**SUBJECT:** RAPID RESPONSE TRANSMITTAL #08-060  
Front Window Belt Molding Noise, Loose or Sticking

2008 (WK) Grand Cherokee

FIGURE 1

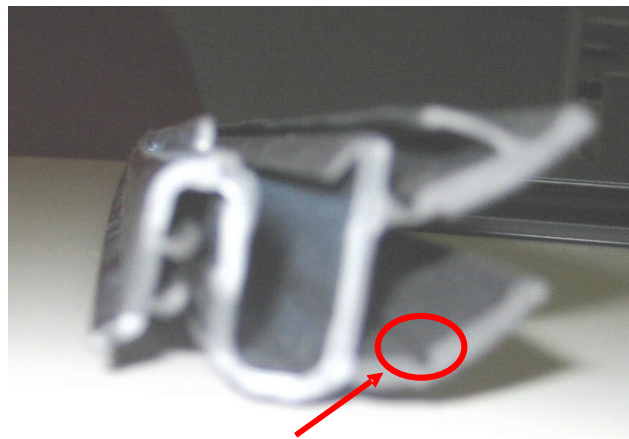
A number of vehicles were built with a front door window belt molding that can exhibit a moan sound or may stick and bind or become loose. Dealers are required to modify the belt molding on both doors.

1. Roll both the front windows down fully.
2. Insert a sharp, slim razor knife into the slot near the lock knob and cut the inner belt molding's lower seal lip by the notch. (Fig 1).

Cut inner belt seal lower seal lip by the notch.
